Supporting Documentation Audlem St James – Bells

Note to parish

Refurbishment of Bells at St James The Great Audlem

APPENDIX A

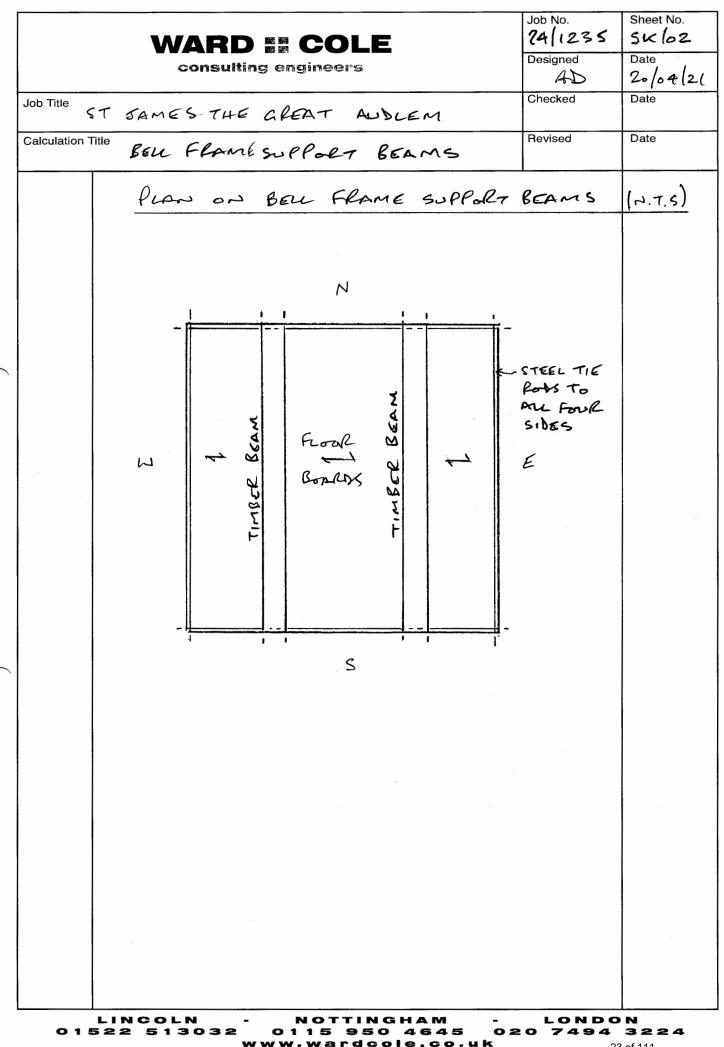
- 4.02 In the longer term, it is recommended that the bell frame support beams are more rigidly fixed to the tower walls, using fabricated and galvanised mild steel brackets, through bolts and resin anchors. A suggested detail is given on sheet SK/080001740900 endix A to this report. This will prevent any differential movement occurring between the beams and the tower walls when the bells are rung full circle. Where possible, the beams should also be connected to the bottom sills of the bell frame with galvanised vertical through bolts where the beams and sills intersect.

- 4.03 In order to reduce the differential horizontal movement between the top sills of the bell frame and the tower walls, it is recommended that substantial galvanised angle brackets are installed and fixed with horizontal through bolts and plates to the vertical faces of the top sills of the bell frame at their intersections. This is a common detail and your chosen bell hanger will be able to fabricate and fix these. Consideration should also be given to installing galvanised vertical tie bolts washer plates and nuts to connect the top and bottom sills of the bell frame where possible. It may also be necessary to install hardwood packs to fill any gaps which exist. Again, your chosen bell hanger will be able to advise on this.

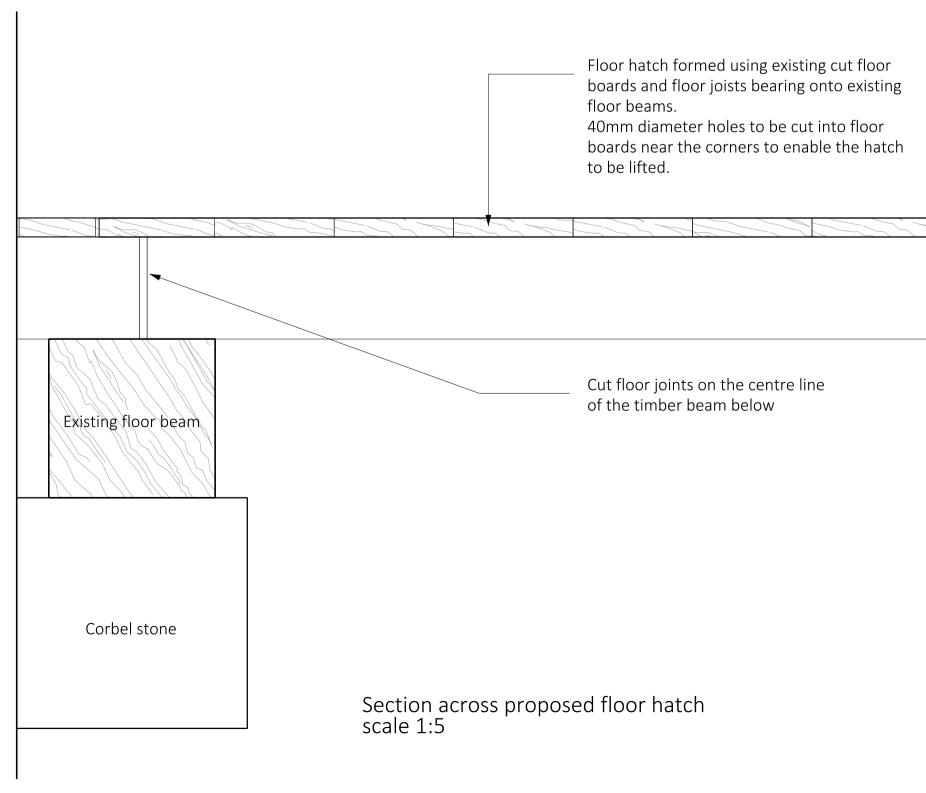
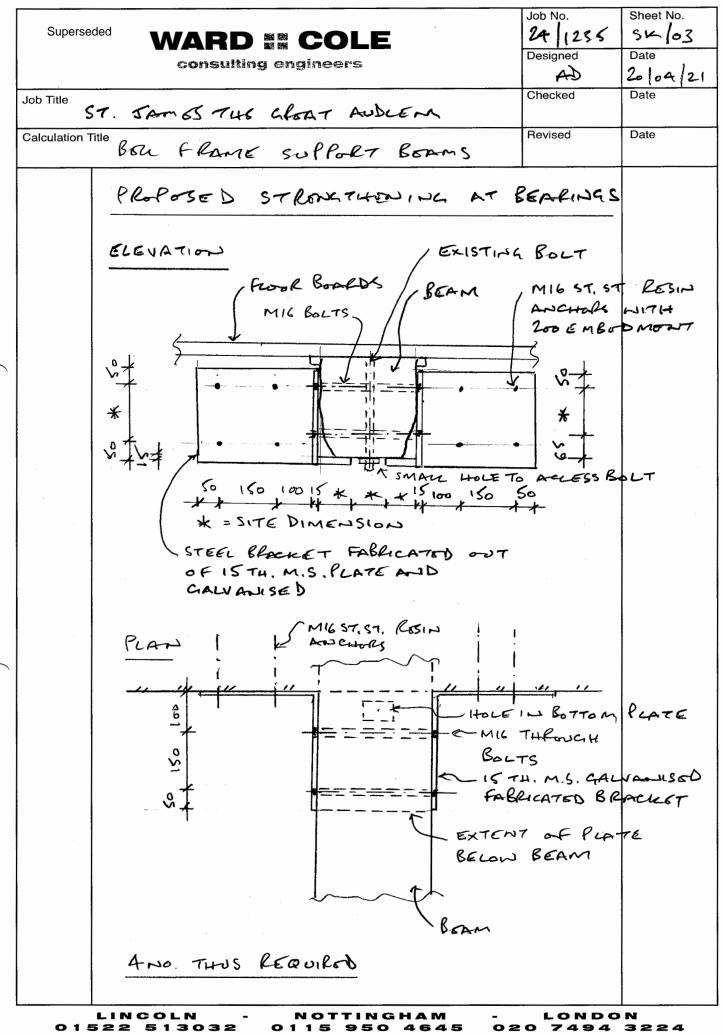
Stair opening
Existing floor boards carefully cut along along the centre line of the floor joists to create the opening for the hatch		
2no. existing floor joists to be cut on the		
central line of the floor beams maintaining adequate bearing for retained joists in situ and the parts forming support for the new floor hatch		
Existing timber floor beams		
Evisting store carbola		
Existing stone corbels	Proposed floor structure plan

Carpet to ringing chamber to be lifted to enable works to be undertaken and to be re-fitted on completion.

If only the lowest trap in the ringing chamber required to be cut and trimmed (as per specified drawing from Buttress Architects) the cost of this as a stand-alone item would be **£496.00 plus VAT.**

Figure 3. Plan of frame at frame-head level, north to the top, showing the relative position to the tower walls, drawn to a scale of 1:20, reduced to 70%. Positions of belfry windows are covered and hence not measured.

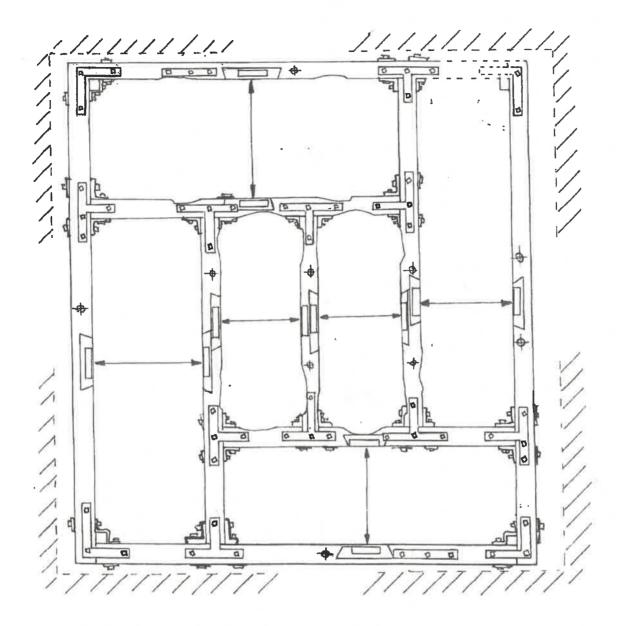
23no. CORNER CLEATS WITH THROUGH BOLTS AND BACKING PLATES FITTED TO FRAME HEADS.

17.2.23 10NO. TIE BARS ADDED SHOWN AS \$

The plan drawing attached shown as figure 3 dated 28.11.22 and 17.2.23 taken from Dr John Eisel's sketches shows 23no. corner cleats fitted to the bellframe head cill junctions. It is our intention that the existing top mounted 'T' bars will remain intact, and that their fixings will be checked and tightened.

The plan drawing shown as figure 3 is also marked up with 10no. vertical tie bars fitted through bellframe trusses marked as 1-4 and 7-10. These tie bars to be formed from M20 or M24 round bar threaded at each end and provided with top and bottom plates and nuts.

Plan of frame at sill level, showing roping positions of the six bells at the Figure 4. level of the pulleys, drawn to a scale of 1:20 and reduced to 70%.

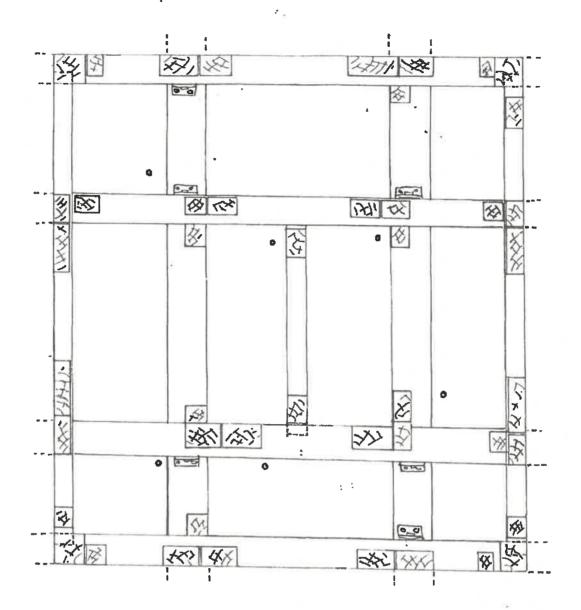
The plan drawing shown as figure 4 dated 28.11.22 taken from Dr John Eisel's sketches shows 6no. base cleats fitted to connect the bellframe vertical post to base cill junctions. These cleats will enhance bellframe lateral stiffness in conjunction with the corner cleats. These cleats are also marked up on figures 5-8.
